ADDENDUM NO. 1

April 18, 2017

TO THE CONTRACT DOCUMENTS FOR
PIEDMONT HILLS HIGH SCHOOL
Building D Science & Classroom Buildings
for the
EAST SIDE UNION HIGH SCHOOL DISTRICT

DSA # 01-116180 - FILE NO. 43-H10

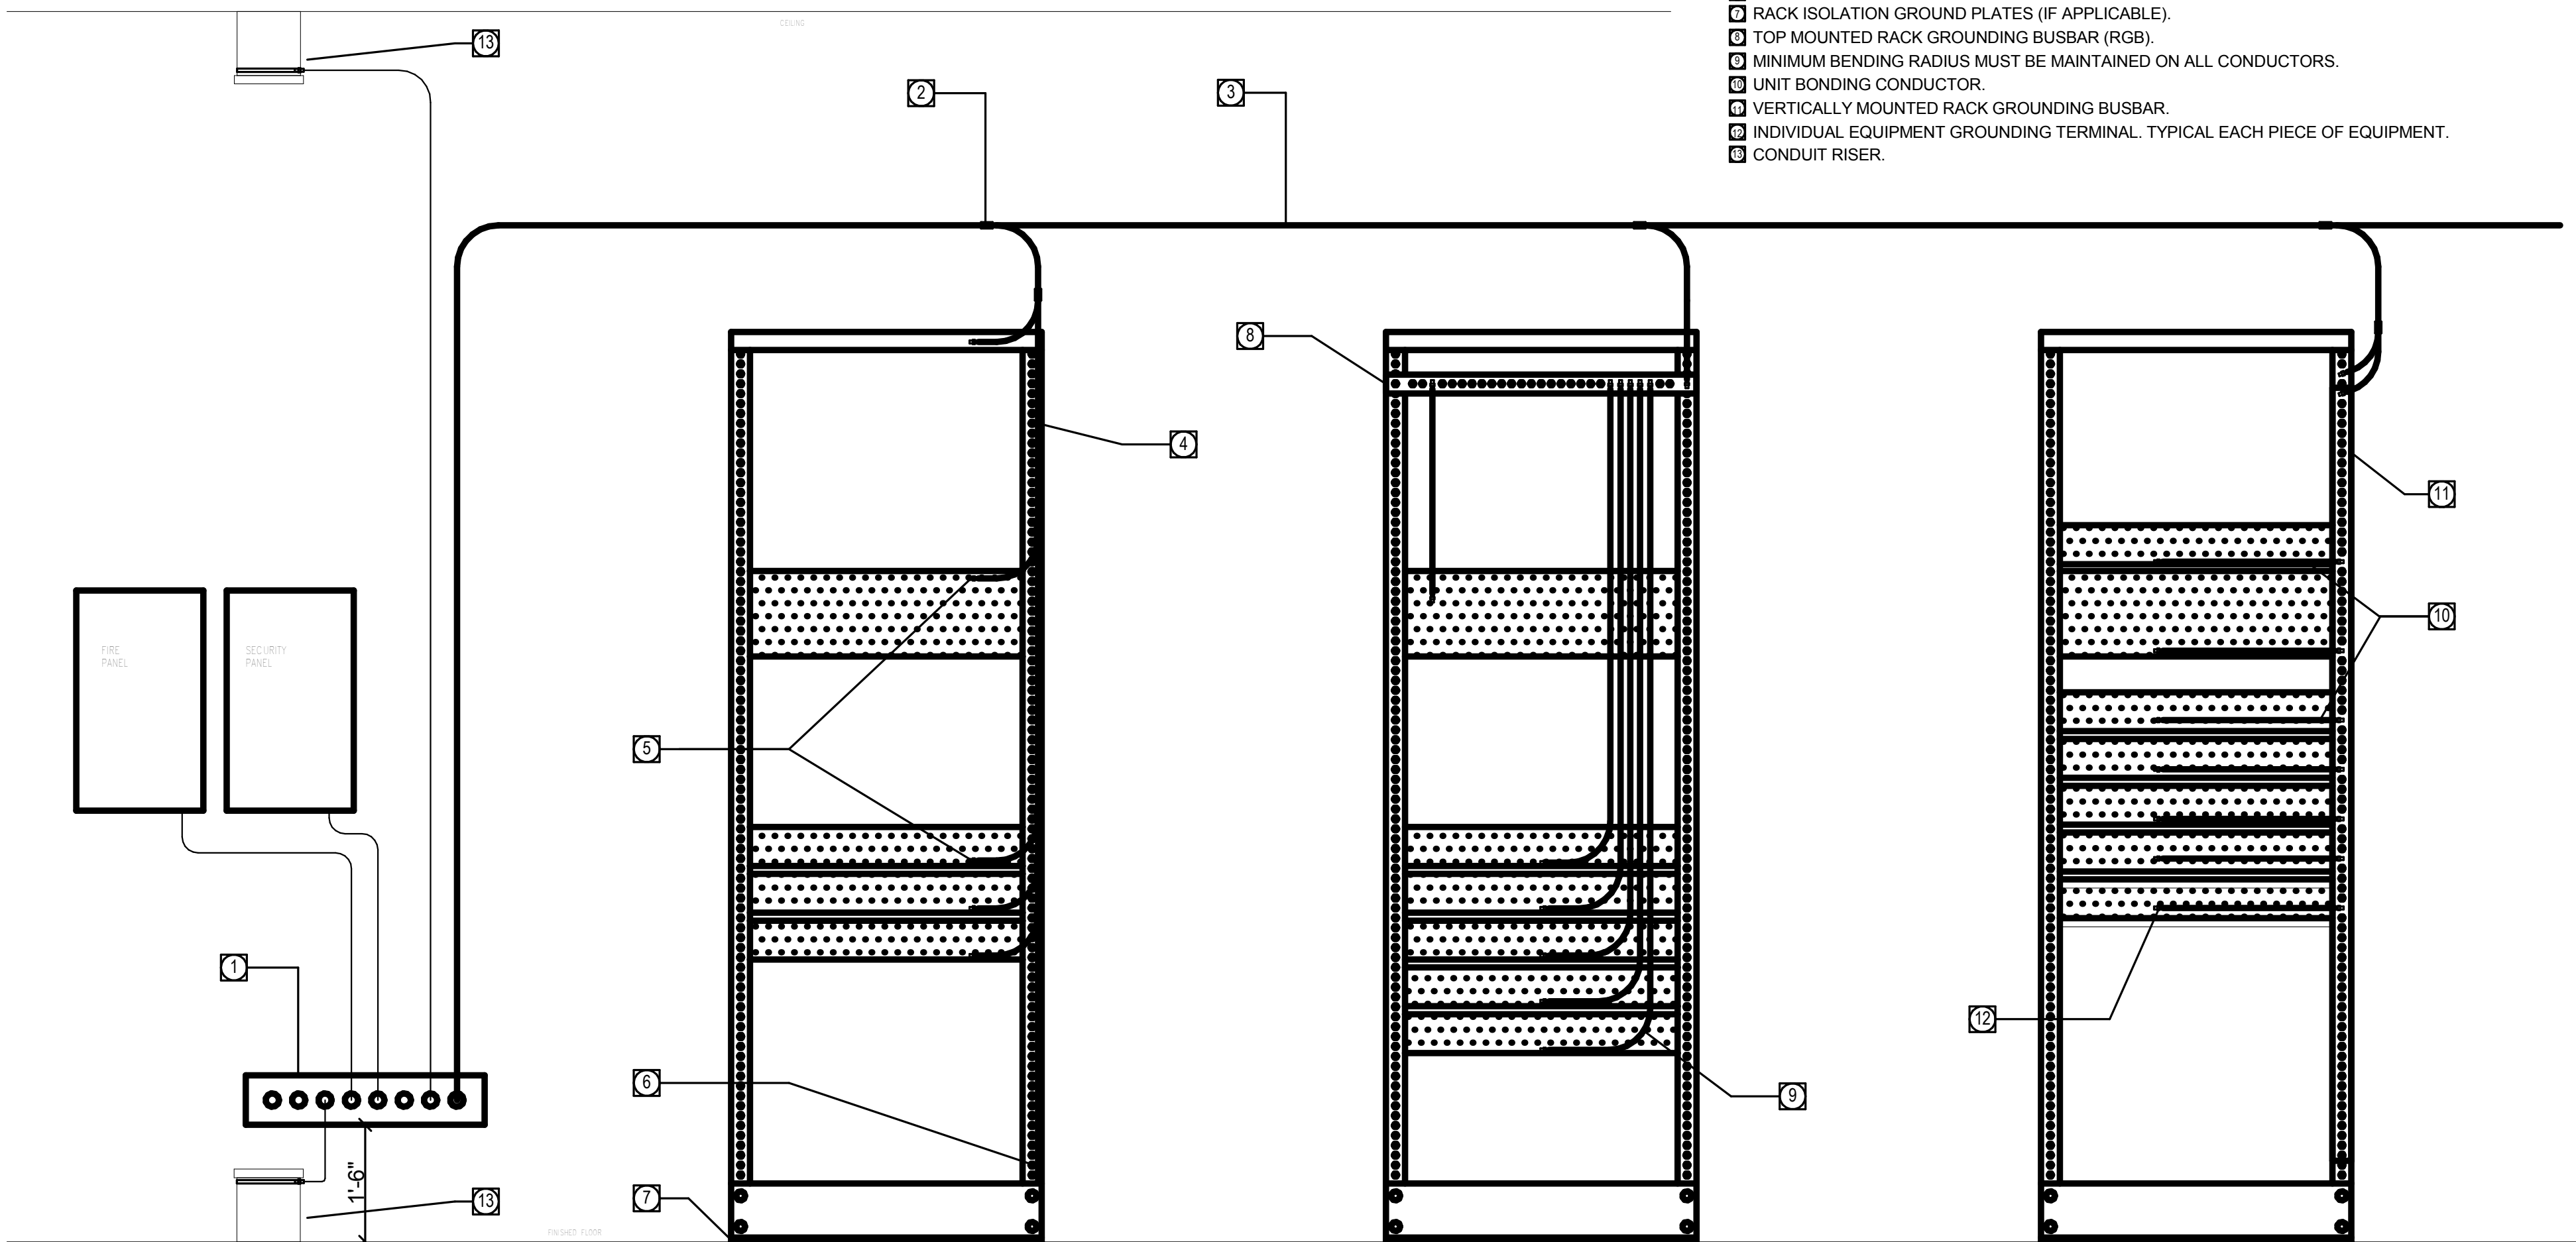
ITEM NO. AD1 -22 Delete sheet T4.01. Replace with sheet T4.01, Technology Typical Details.

- a) Revise MDF Copper Backbone Elevation Standard detail to include call-out for 25 pair ISP termination tails.
